STATE OF OHIO
DEPARTMENT OF TRANSPORTATION
MAH-680-4.58
PART 1
CITY OF YOUNGSTOWN
MAHONING COUNTY
FOR PART 2 SEE MAH-680-4.58

FEDERAL PROJECT NUMBER
E250327
RAILROAD INVOLVEMENT
NONE
PROJECT DESCRIPTION
THE PROJECT CONSISTS OF FULL DEPTH PAVEMENT REPLACEMENT OF MAHONING I.R. 680 FROM THE S.R. 193 INTERCHANGE (SLM-4.58) TO SOUTH OF THE SOUTH AVENUE INTERCHANGE (SLM-7.37), ALL INTERCHANGE RAMPS WITHIN THE CORRIDOR WILL BE RECONSTRUCTED, INCLUDING RAMPS TO AND FROM S.R. 193 AND U.S. 62/S.R. 7. INCLUDES BRIDGE WORK TO MAH-680-4.886 (SFN 5006872). THIS PROJECT ALSO INCLUDES THE REMOVAL OF THE MAHONING AVENUE ENTRANCE RAMP TO I.R. 680 SOUTHBOUND.
ADDITIONAL WORK INCLUDES GUARDRAIL AND CONCRETE BARRIER REPLACEMENT, ROADWAY DRAINAGE IMPROVEMENTS, SIDEWALK, CURB RAMPS, SIGNING, LIGHTING AND PAVEMENT MARKINGS.

R3 01-13-2026, SUPPLEMENTAL SPECIFICATIONS 813 AND 913 ADDED

CROSS SECTIONS - I.R. 680
 STA. 1090+00.00 TO STA. 1093+00.00

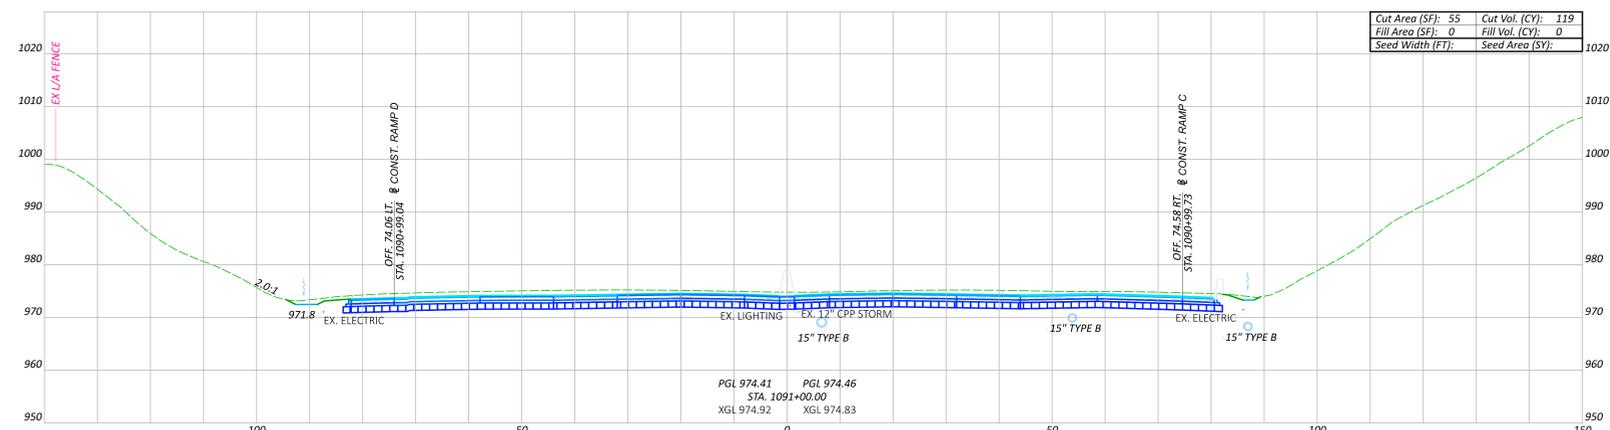
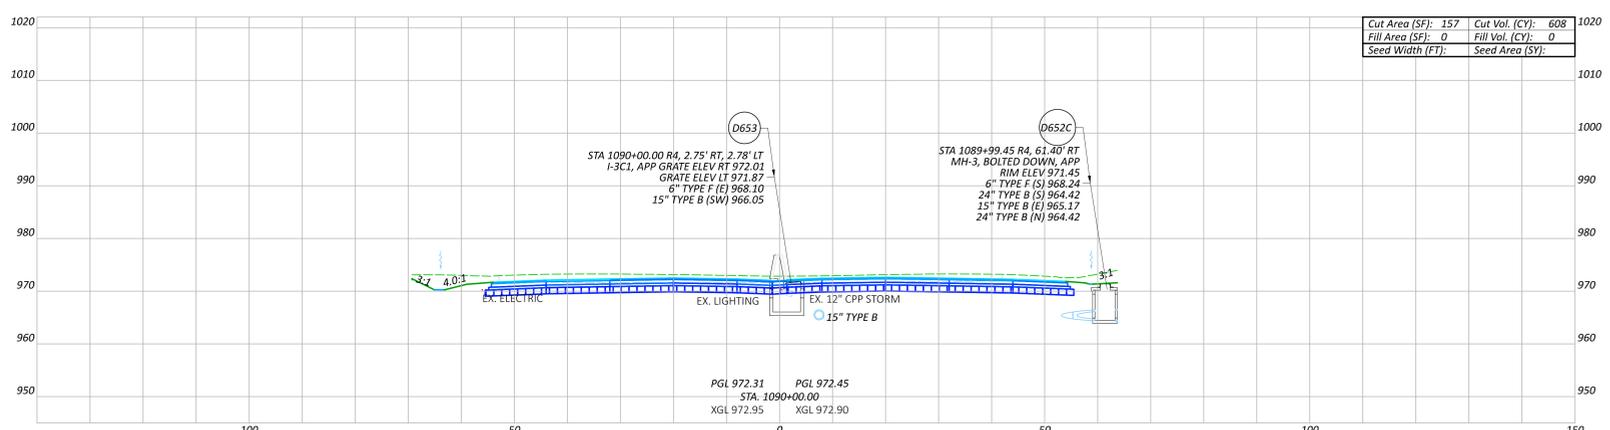
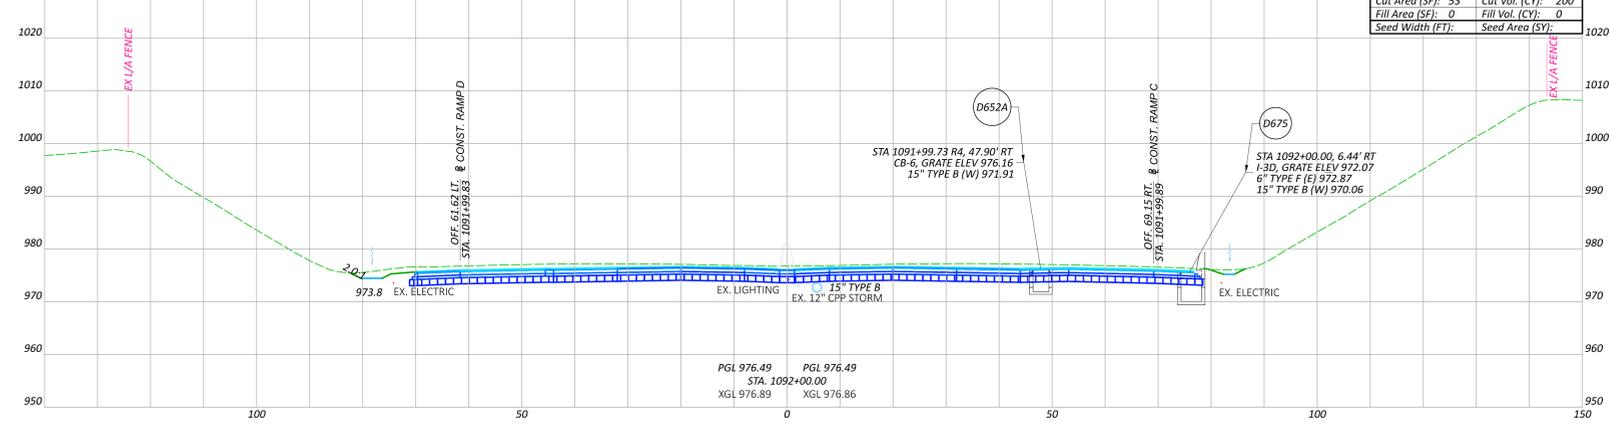
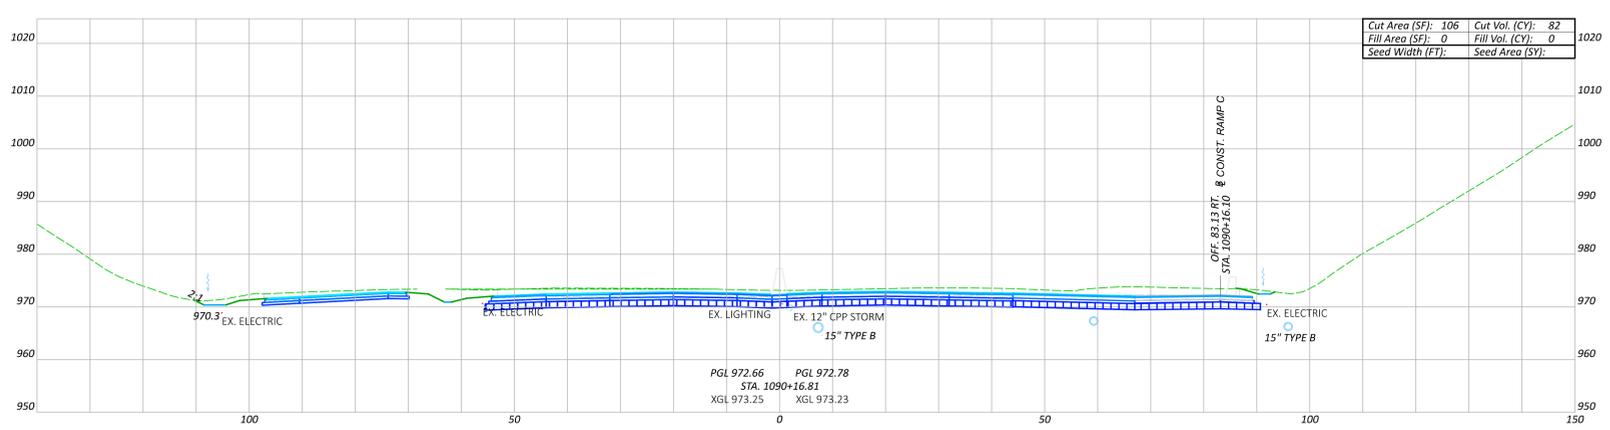
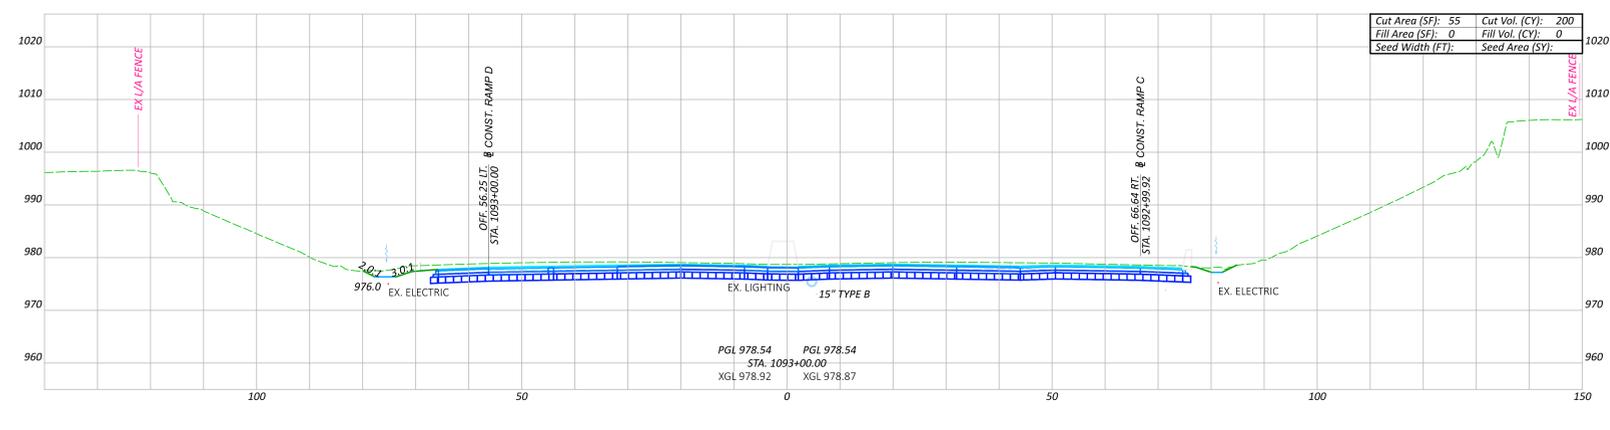
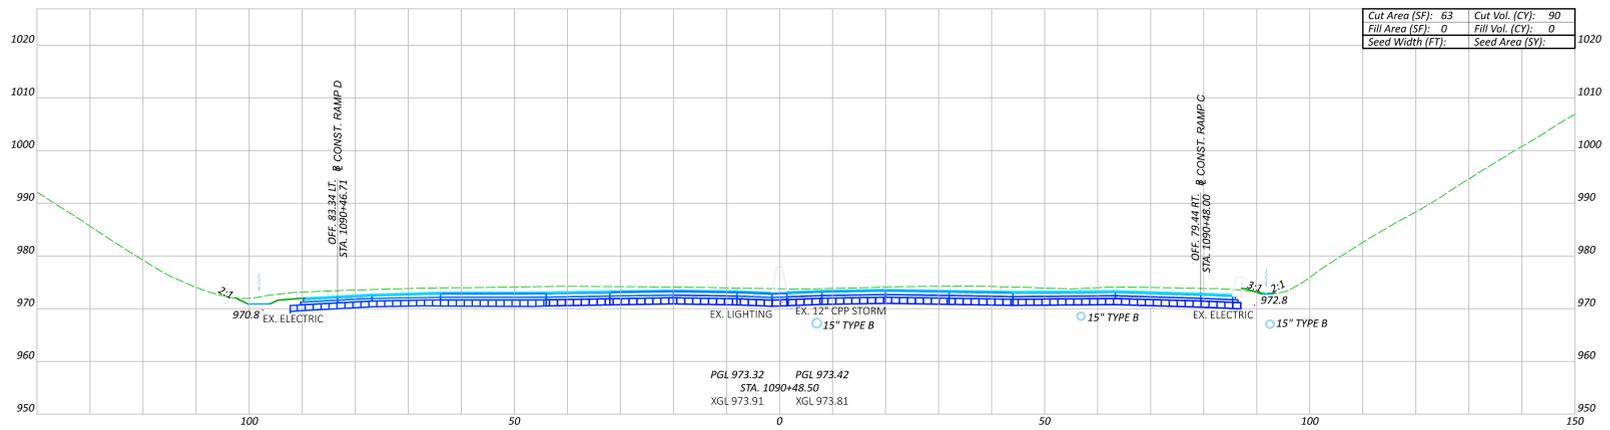
11-13-2026, QUANTITIES REVISED

CROSS SECTIONS - I.R. 680
 STA. 1094+00.00 TO STA. 1097+24.61

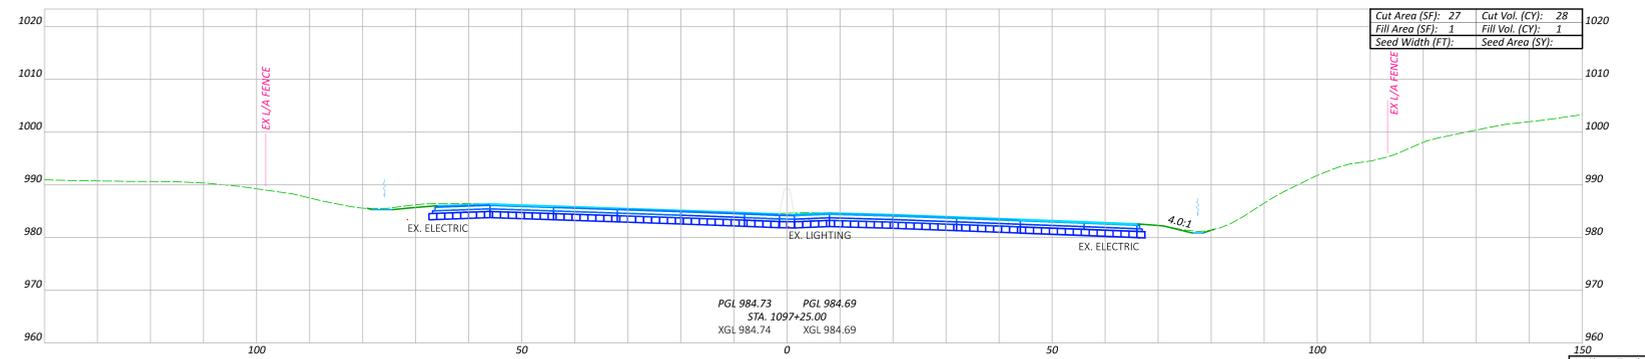
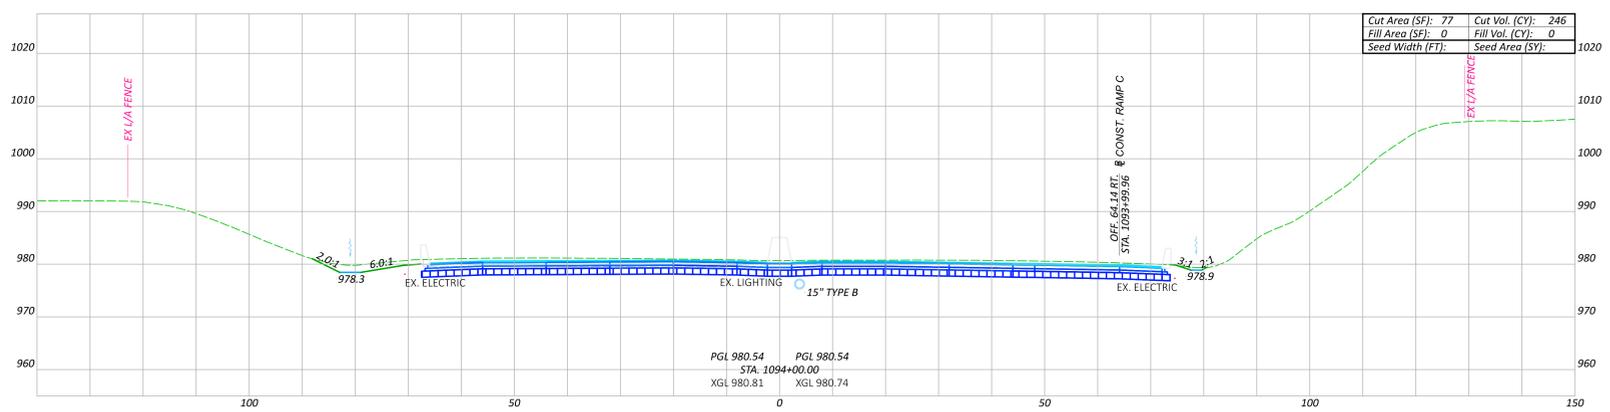
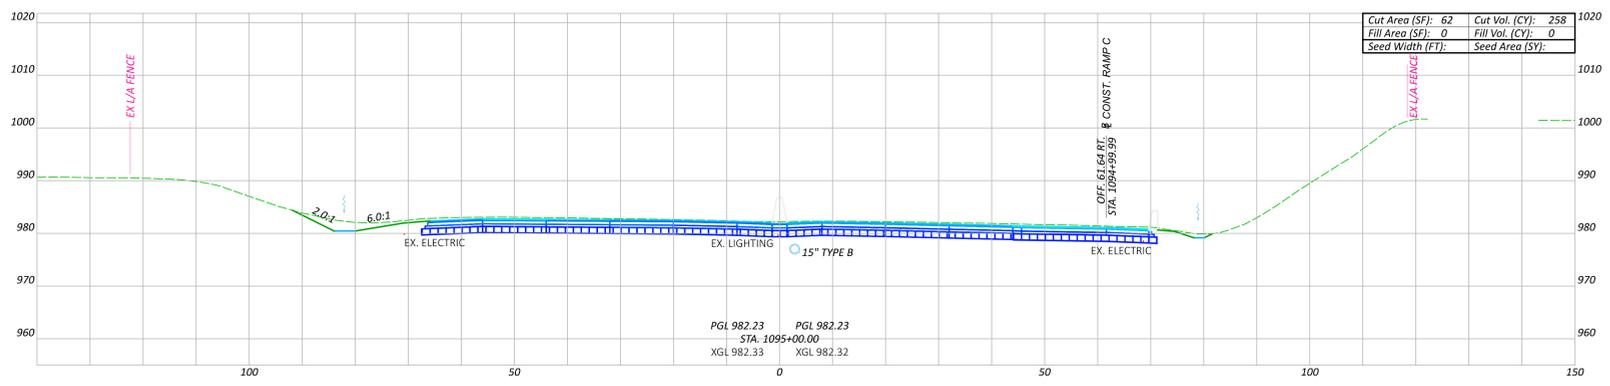
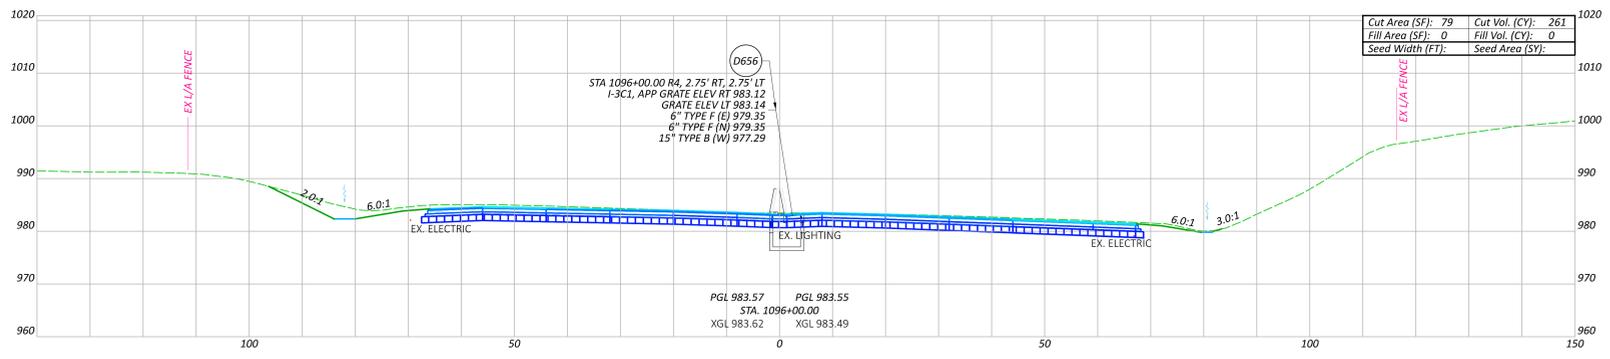
01-13-2026. QUANTITIES REVISED

CROSS SECTIONS - RAMP K AT MARKET ST.
 STA. 8+00.00 TO STA. 13+00.00

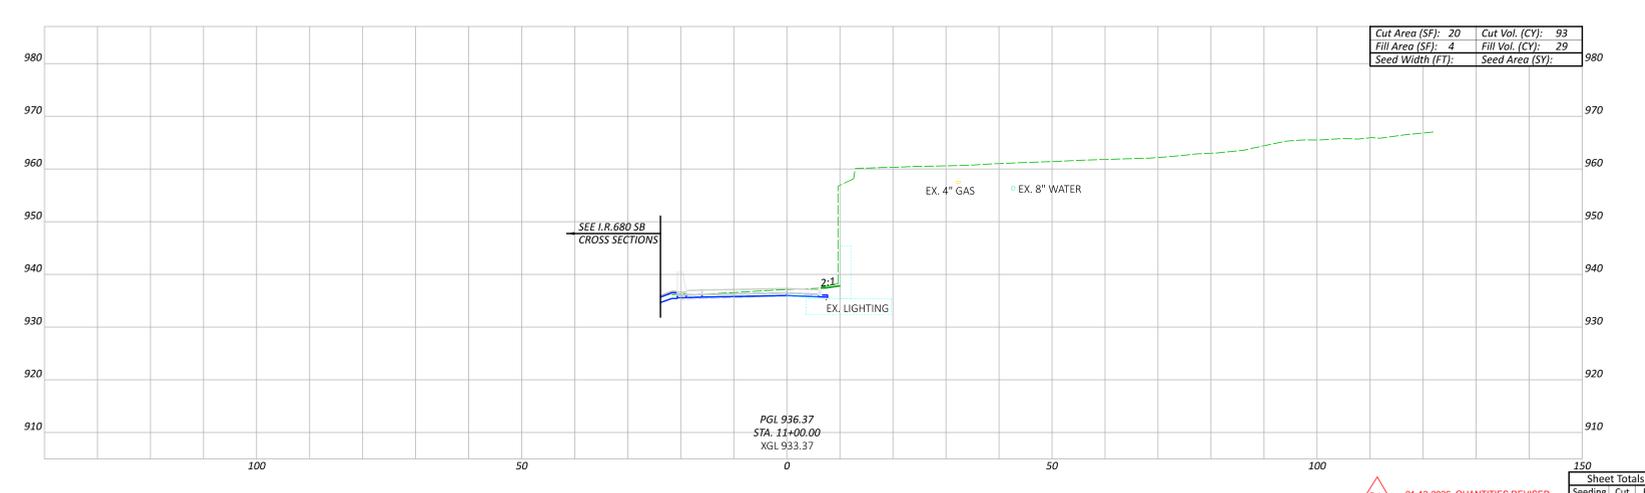
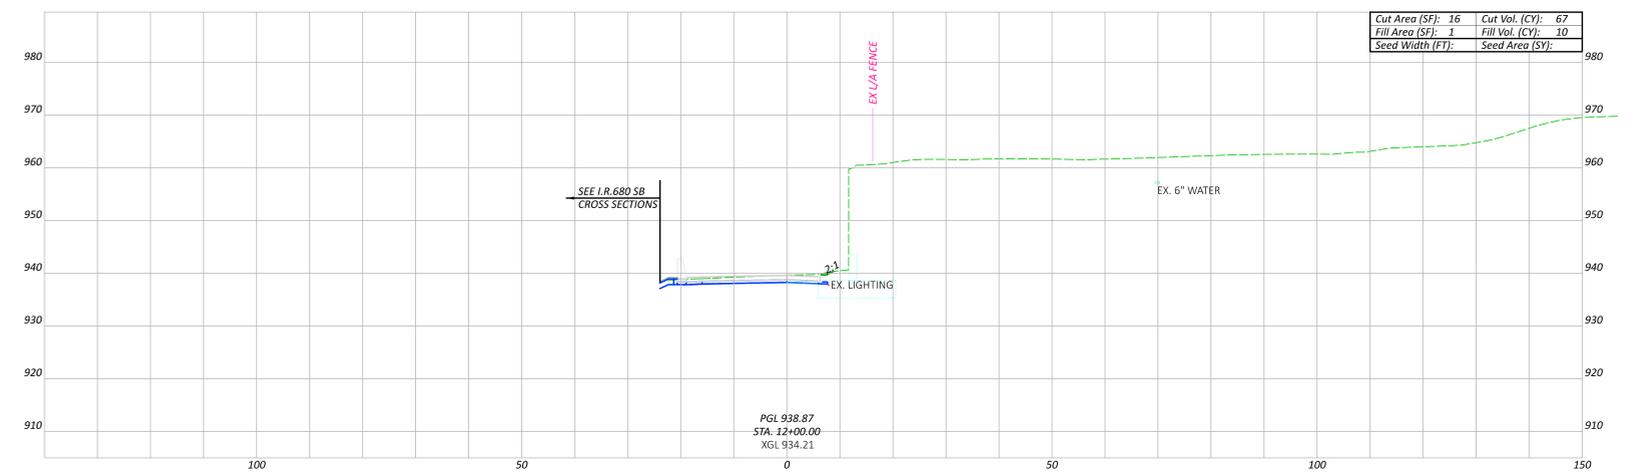
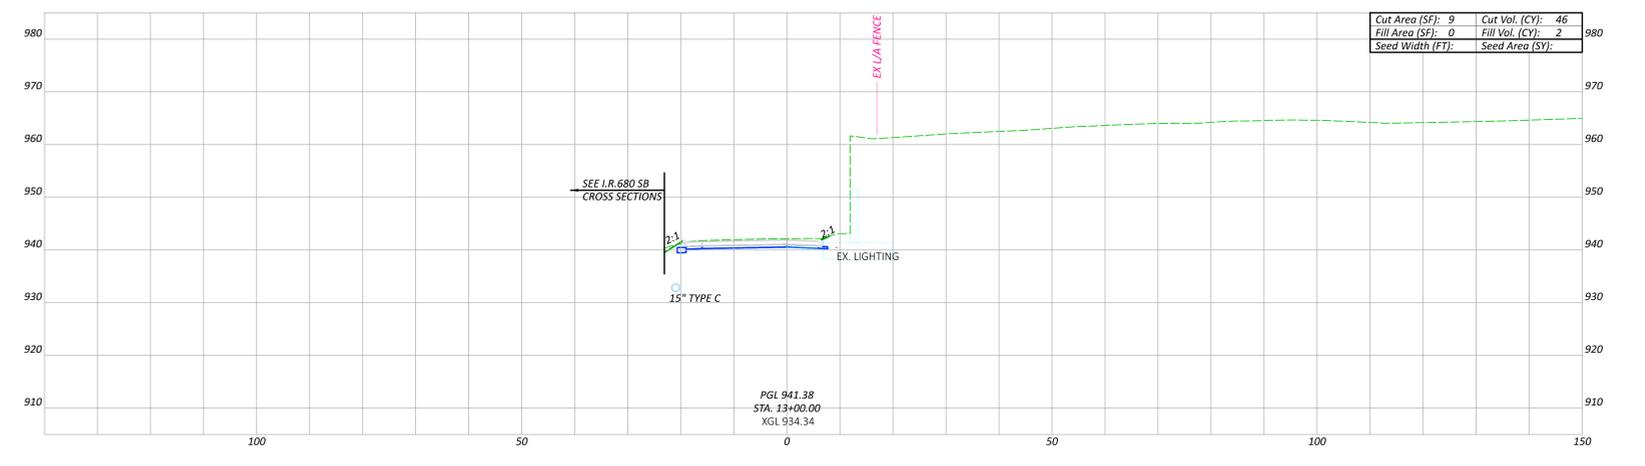
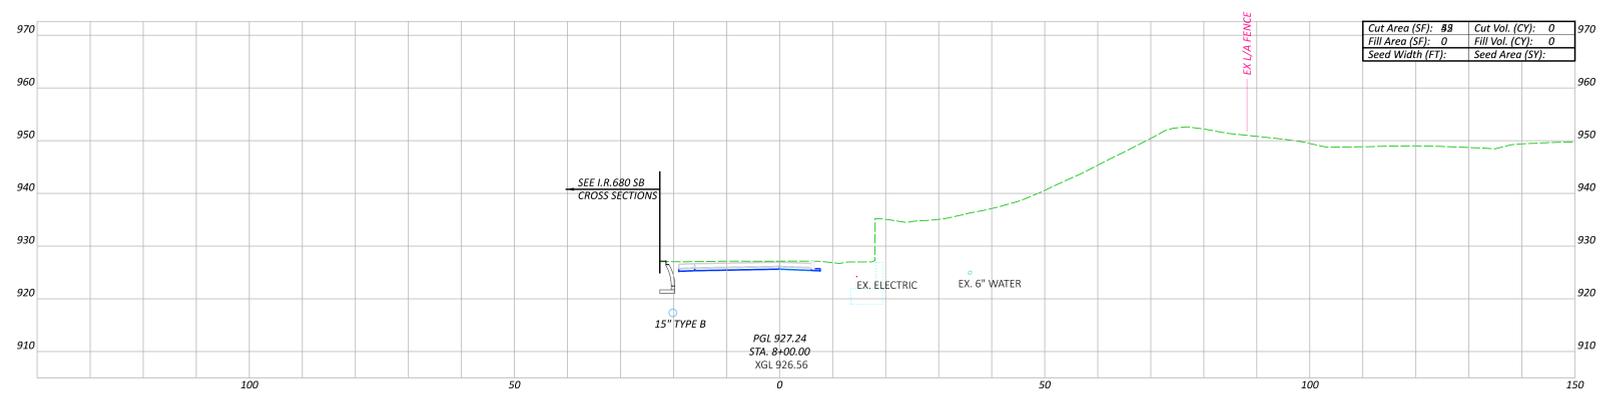
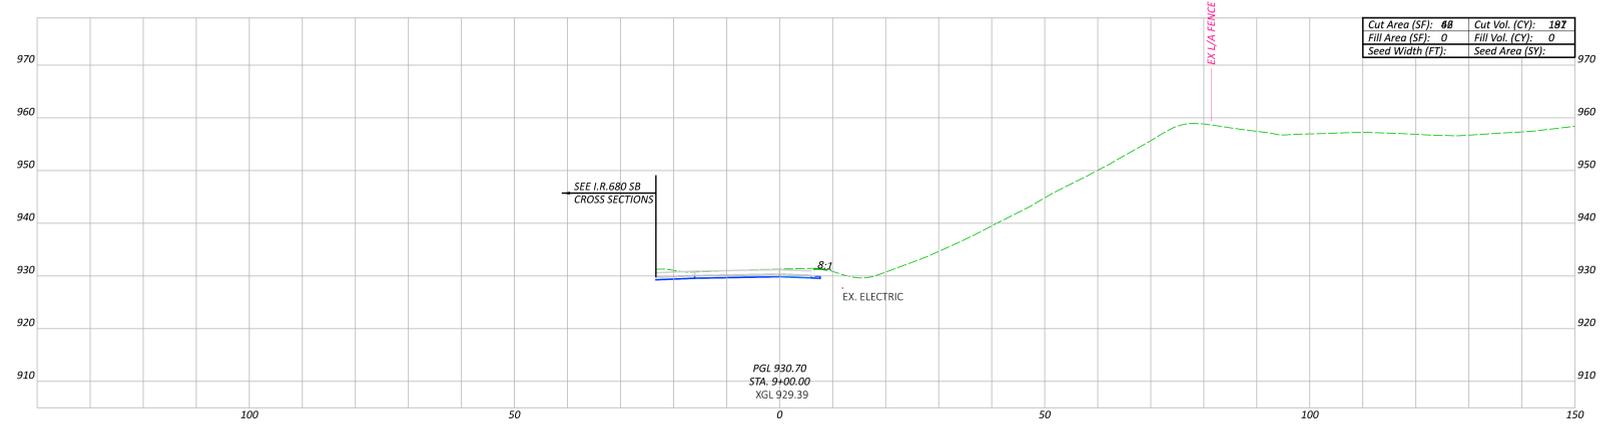
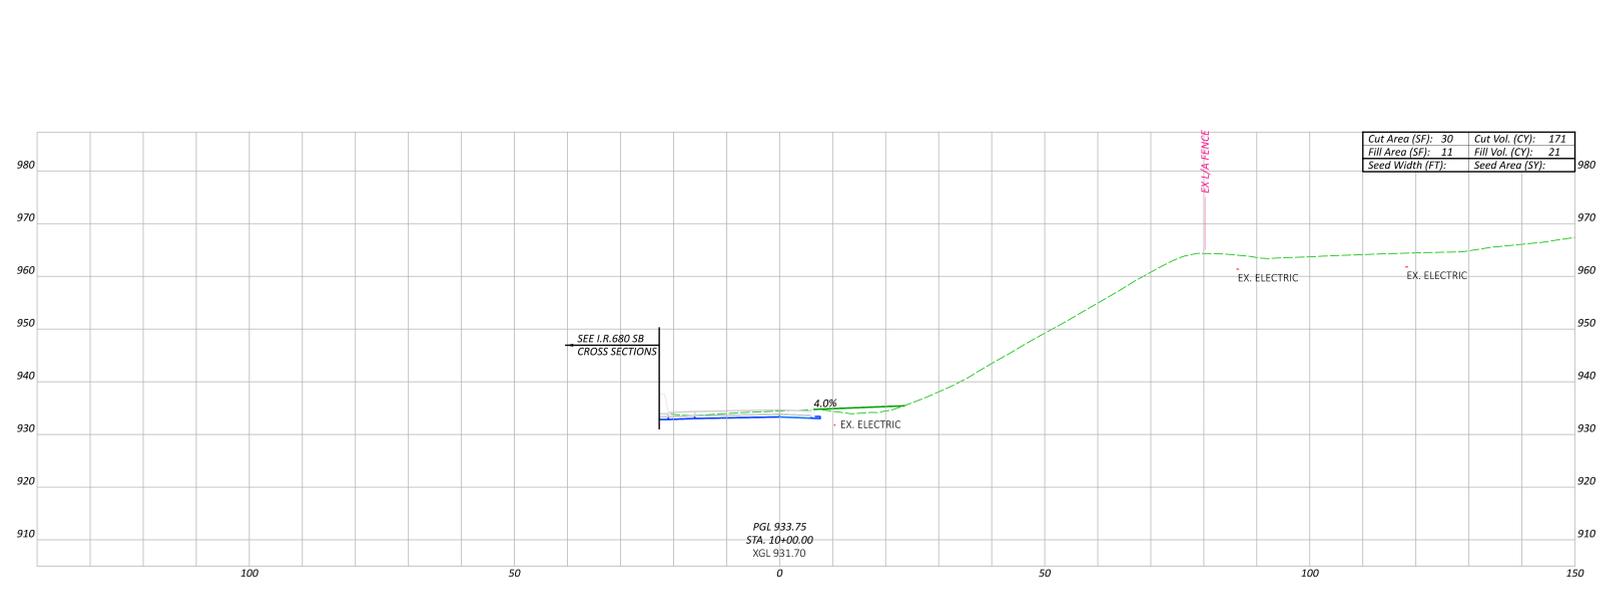
01-13-2026, QUANTITIES REVISED
